**Pacific Gas and  
Electric Company®**

Reference: PG&E Gateway Generating Station (00-AFC-01C)

Subject: PETITION FOR INSIGNIFICANT PROJECT CHANGE TO PLANT FACILITY

**PETITION FOR INSIGNIFICANT PROJECT CHANGES  
AT  
GATEWAY GENERATING STATION**

PG&E, GATEWAY GENERATING STATION FLOW DIAGRAM

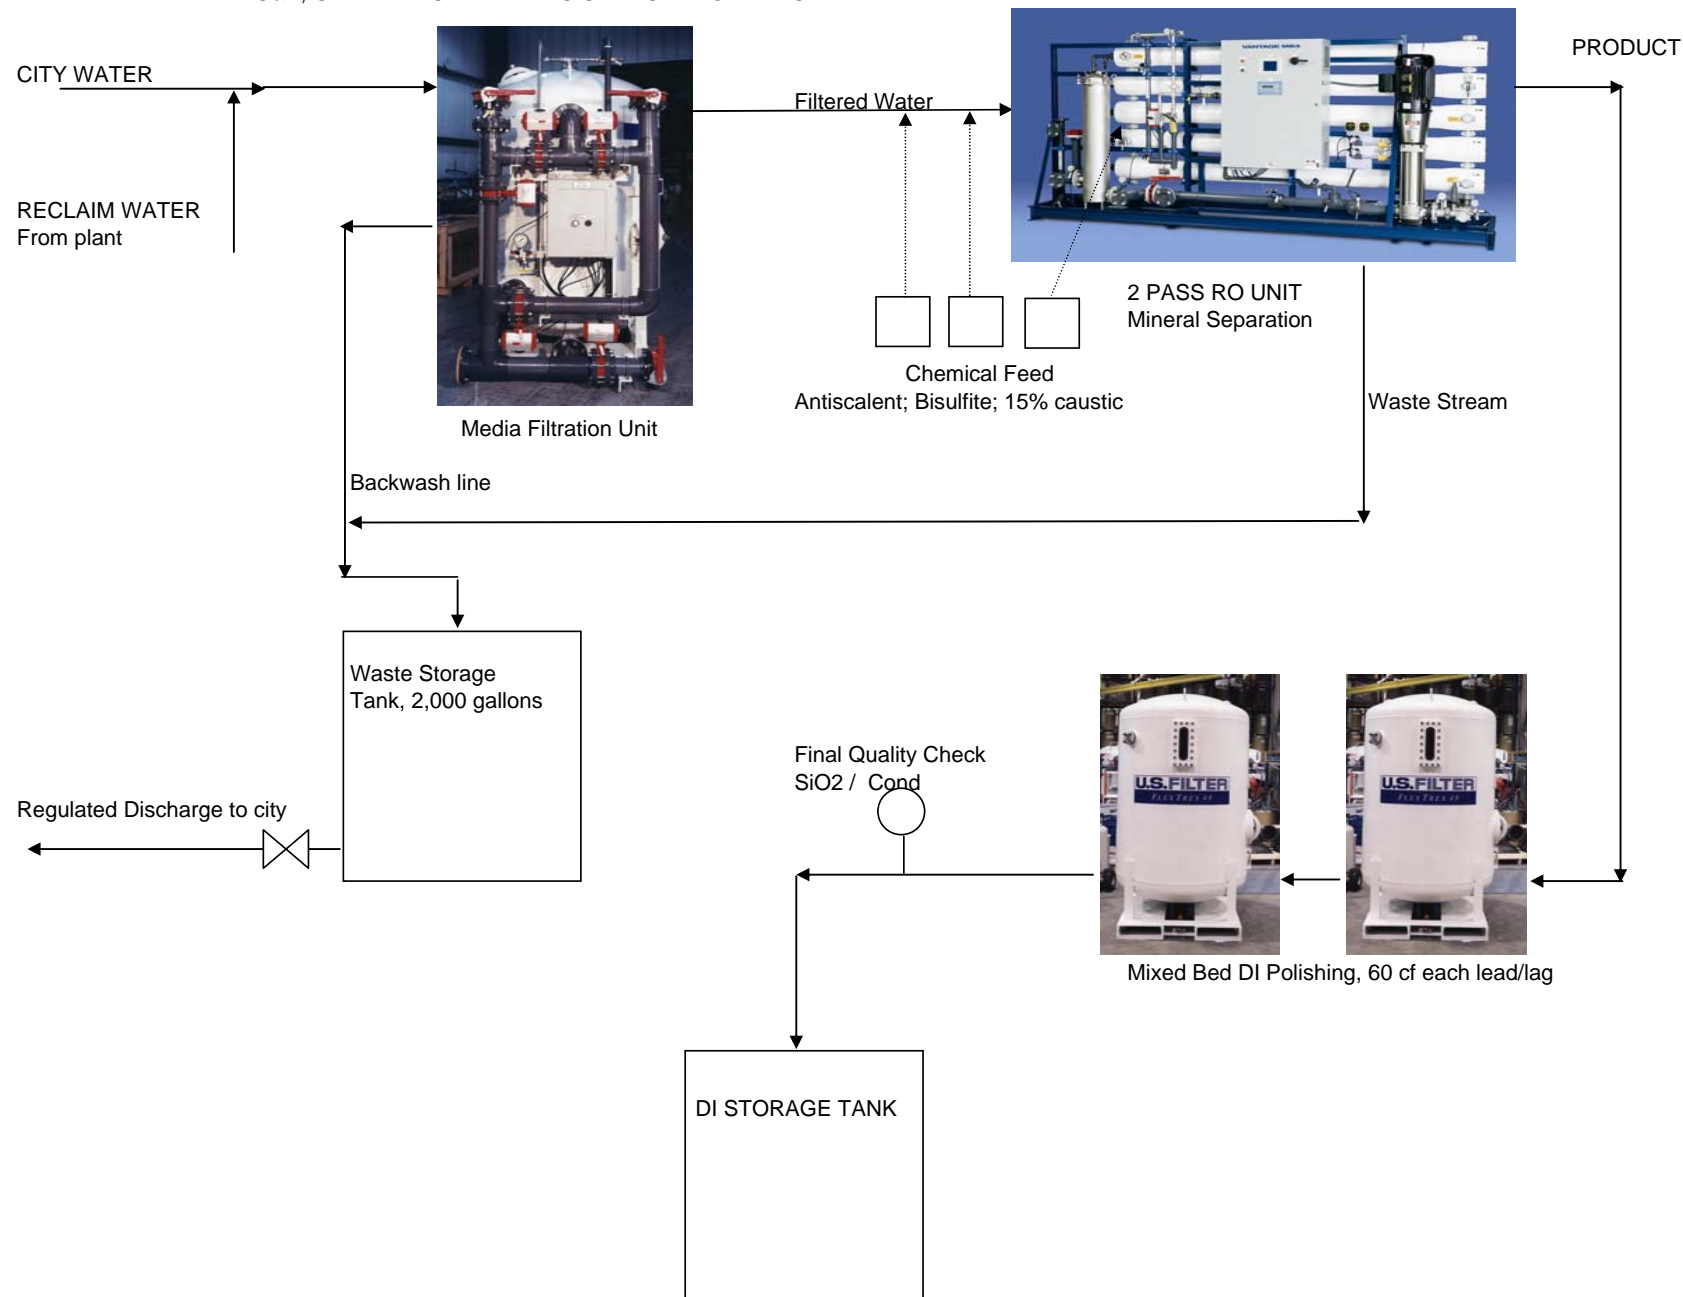
1. Replacement of Trailer-mounted Demineralized Water Treatment Package with Rack-mounted Reverse Osmosis System
  - a. **Description of Modification:** This modification proposes to replace the existing trailer-mounted demineralized water treatment package with rack-mounted reverse osmosis (RO) system that includes a water polisher. The new installation with area dimension of 5' x 20' will be staged within the existing bermed area (28' x 50'). (See Attachment A: Marked-up Facility Layout for location of the proposed modification.) The RO system will utilize less than 50 gallons each at any given time of sodium hydroxide, sodium bi-sulfite, and Vitec 3000 (a proprietary product with mostly sodium hydroxide as a component). Both sodium hydroxide and sodium bi-sulfite are listed in HAZ-1 Appendix C Table 8.12-4 of the Commission Decision 900-AFC-1). (See Attachment B: RO System Process Description and Flow Diagram.)

PG and E Gateway Generating Power Plant will be providing City of Antioch, CA city water mixed with water from the plant Reclaim tank for processing by Siemens. Design includes specialized iron media filtration, 2 pass Reverse Osmosis to minimize the DI loading as much as possible (99.9% mineral removal), caustic interstage feed for complete CO<sub>2</sub> removal to protect the anion capacity, and two stage lead/lag Mixed Bed DI Polish. The feed water is detailed in the water analysis shown in Attachment A.

Photo of Typical Pre-fabricated Metal Shed

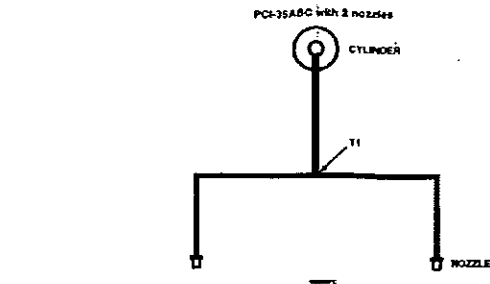
- a. **Description of Modification:** This modification proposes to install a pre-fabricated metal utility shed with dimension: 16' x 40' x 10' H, to store maintenance and mechanical equipment. Concrete flooring will be provided for this installation. (See Attachment A: Marked-up Facility Layout, labeled 3, for location of the proposed modification.) (See Attachment D: Photo of Typical Pre-fabricated Metal Shed.)
